Re: CGO Open Pit Continuation Project - Response to RFI #5

Please find below a response to a request for information (RFI #5) in relation to the Cowal Gold Operations (CGO) Open Pit Continuation Project (SSD-42917792) (the Project) dated 5 July 2024.

Figure 6.1a

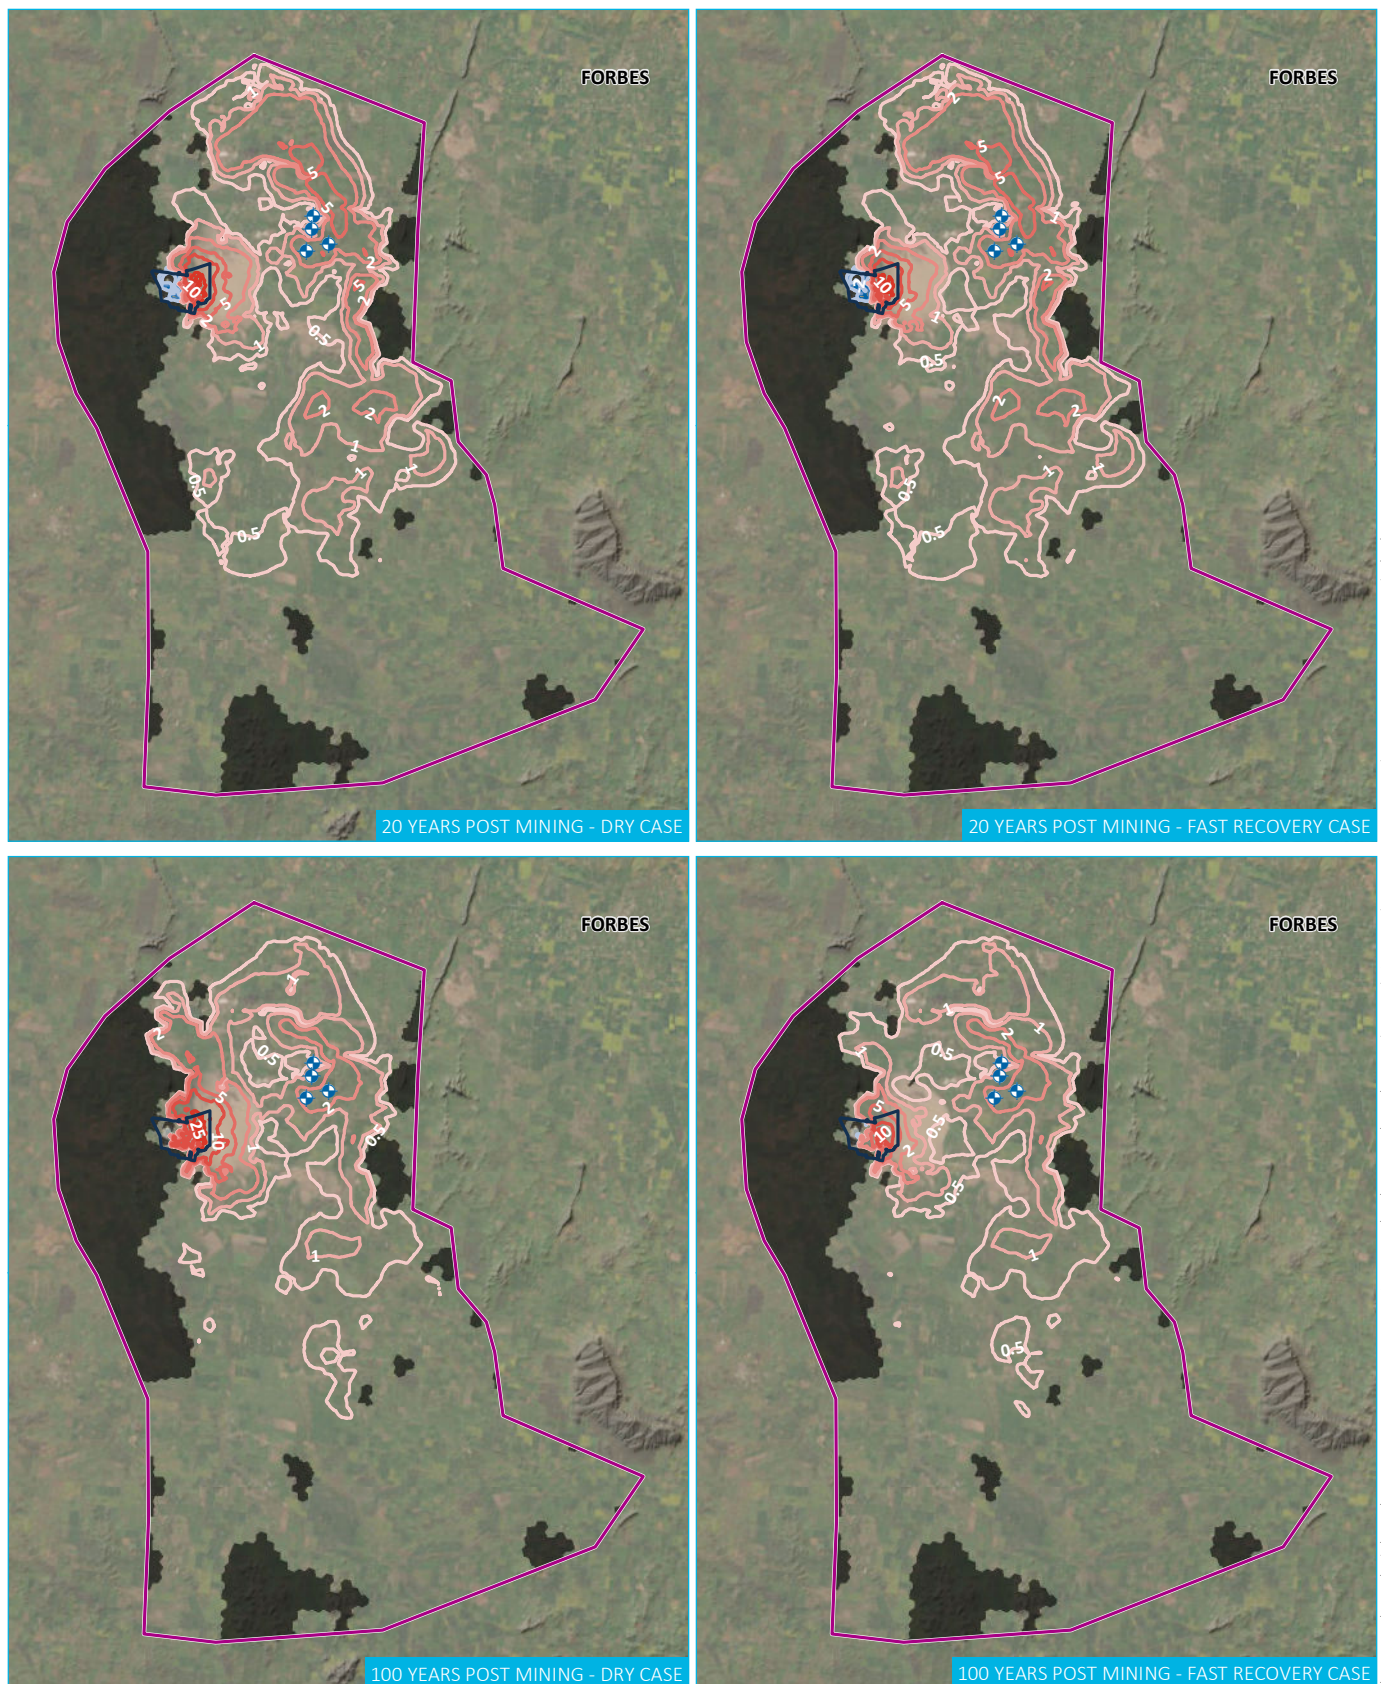
Currently, all drawdown figures appear to represent the impacts of privately owned bores in addition to mining and the Evolution owned Bland Creek Paleochannel borefield. To inform our understanding of the Project impacts without private landholder pumping, please provide figures showing predicted drawdown contours for:

- a) Approved mining plus pumping from the Bland Creek Paleochannel borefield (Evolution's borefield only).
- b) Approved mining plus pumping from the Bland Creek paleochannel borefield (Evolution's borefield only) plus the proposed Project (including pumping from the Bland Creek Paleochannel borefield only).
- c) Incremental drawdown from the proposed Project only (including pumping from the Bland Creek Paleochannel borefield (Evolution's borefield only).

The current cumulative drawdown figures presented in the Groundwater Impact Assessment **do not** represent any impacts of privately owned bores. The modelling of drawdown from the Project ('Proposed scenario'), when offset by the 'Null scenario', effectively cancels the extraction of water from privately owned bores out, and therefore these impacts do not appear as a contribution to the cumulative groundwater drawdown for the Proposed scenario in the figures presented (i.e. cumulative drawdown figures = Proposed scenario – Null scenario). Therefore scenario (b) drawdown figures in the request above are already presented in the Groundwater Impact Assessment and includes:

- *Figure 6.1a Cumulative drawdown Upper Cowra groundwater system (Layer 2) map 1 of 2 (at end of mining)*
- *Figure 6.1b Cumulative drawdown, Upper Cowra groundwater system (Layer 2) map 2 of 2 (20 years and 100 years post mining under a dry case and fast recovery rate scenario)*
- *Figure 6.2a Cumulative drawdown, top Lachlan Fold Belt (Layer 7), map 1 of 2 (at end of mining)*

Evolution Mining
Cowal Gold Operations
Open Pit Continuation Project
Response to Request for Information
Figure C1

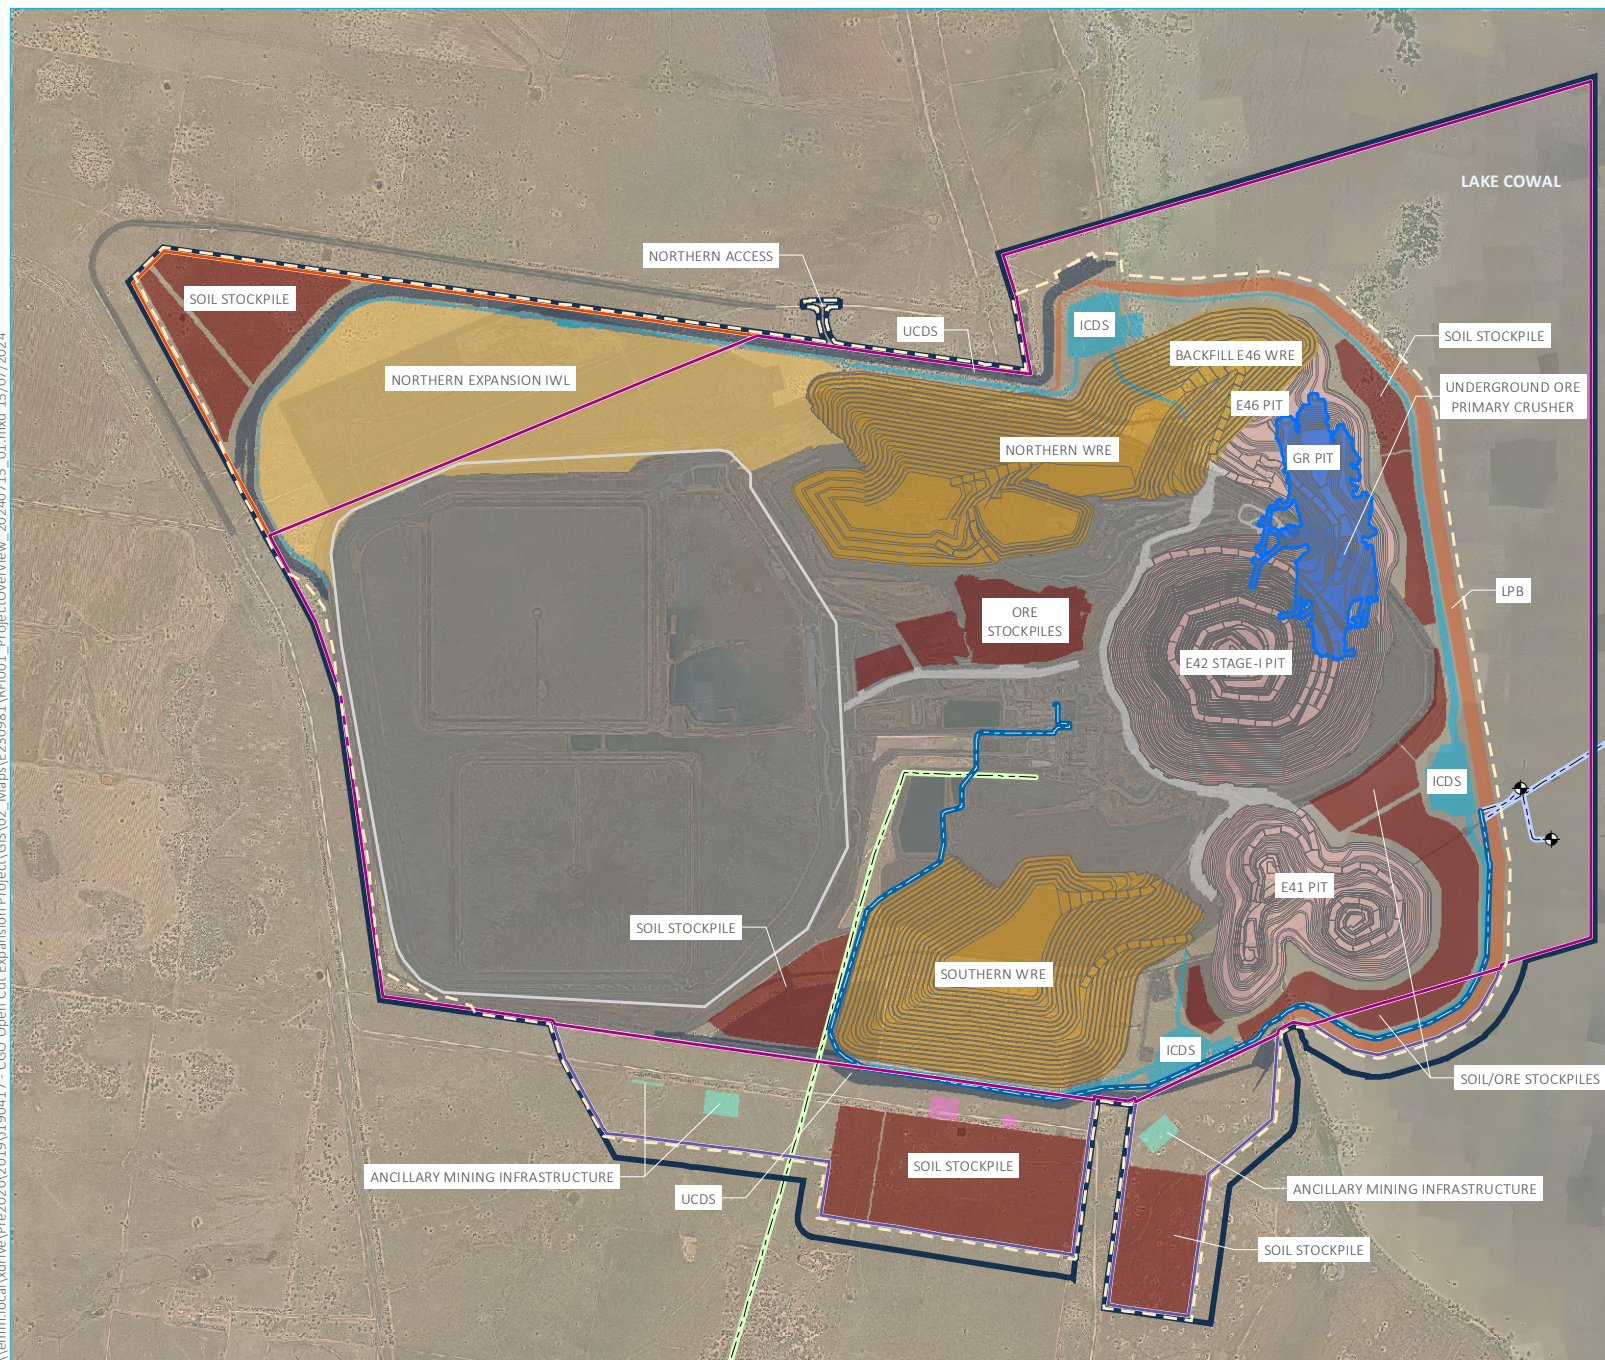
Please provide a figure of the proposed Project layout including the underground mine layout.

The figure requested is presented in Appendix C.
